## Application for Licence Amendment

| Licence Number           | L8345/2009/3   |
| <b>Premises</b>          | King of the Hills Gold Mine<br><br>LEONORA WA 6438<br><br>Legal description –<br><br>Part of mining tenements M37/67, M37/76, M37/90, M37/201, M37/222, M37/248, M37/330, M37/410, M37/429, M37/449, M37/451, M37/457, M37/547, M37/548, M37/572, M37/573, M37/574 and M37/1105<br><br>As defined by the Premises maps attached to the Revised Licence |
| <b>Date of Report</b>    | 28 April 2025  |

Figure 3: Site layout displaying tailings and return pipeline locations

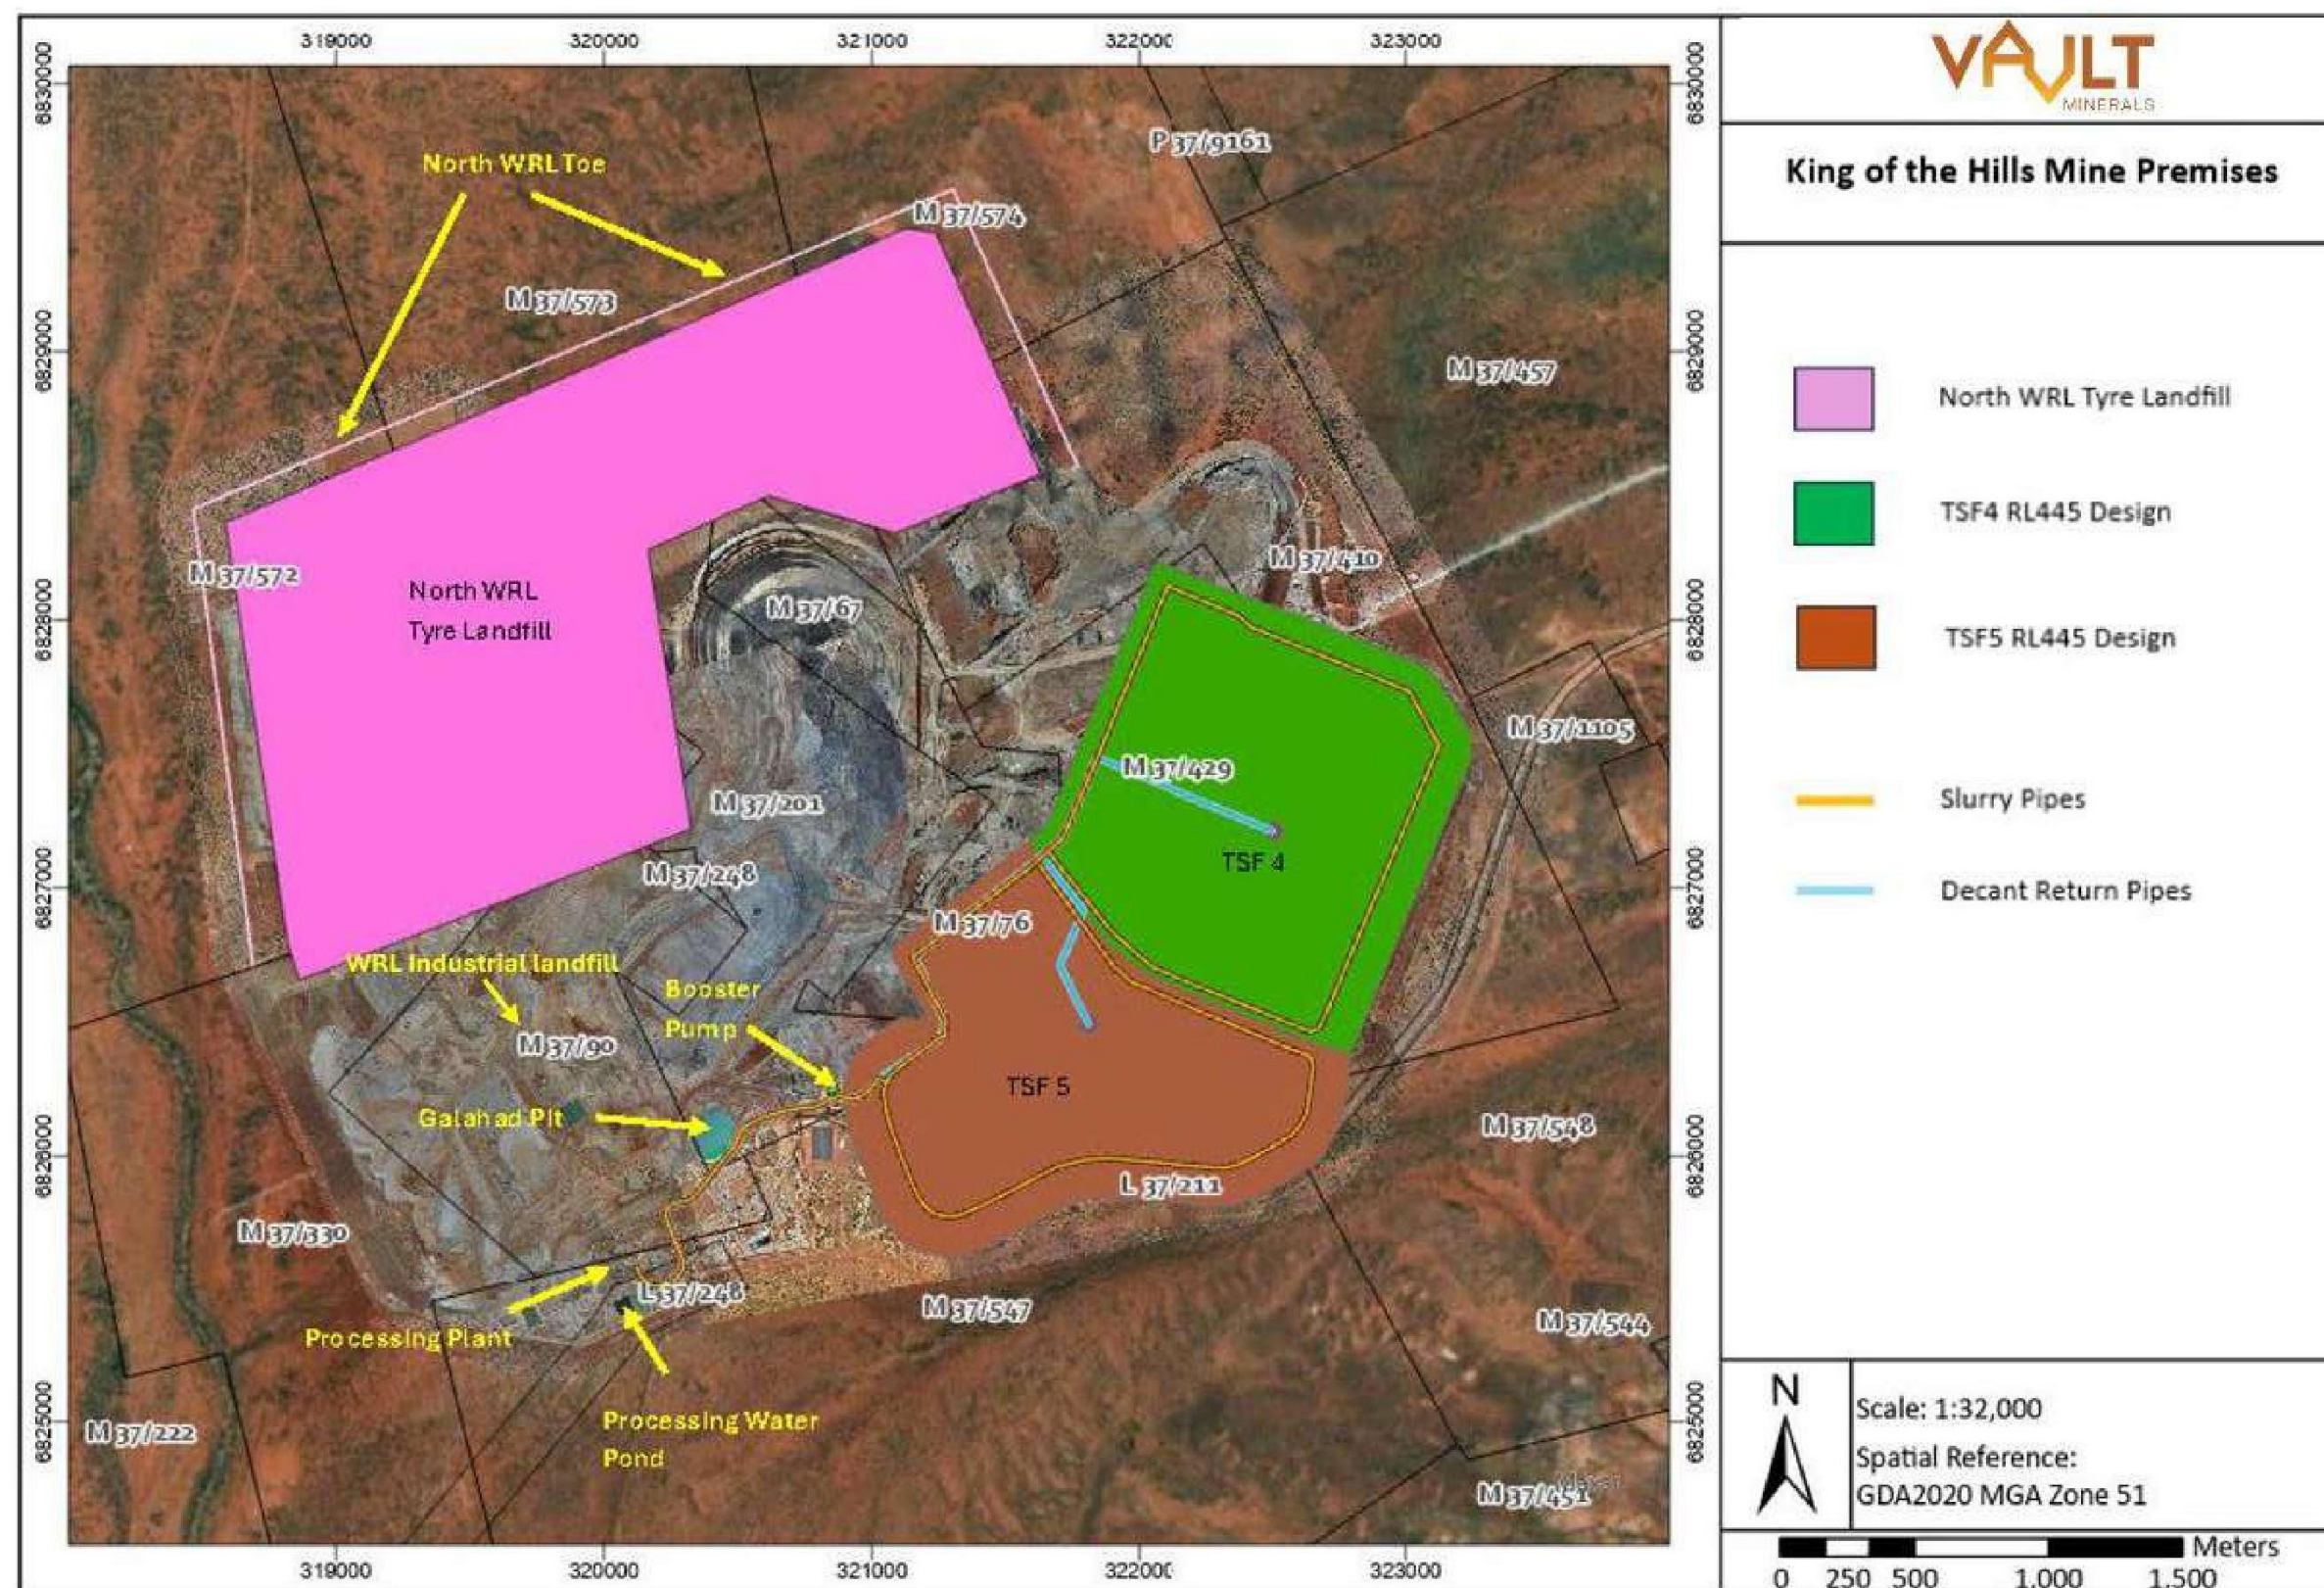
- Upgrade of tailings pumps and discharge pipework involving upgrading the existing tailings disposal pumps and sections of the tailings disposal pipework (Figure 3). All existing bunding, telemetry/shut off valves will be retained; and
- Upgrade of the existing Reverse Osmosis (RO) Plant (an associated activity with category 5 although not directly covered under this licence)
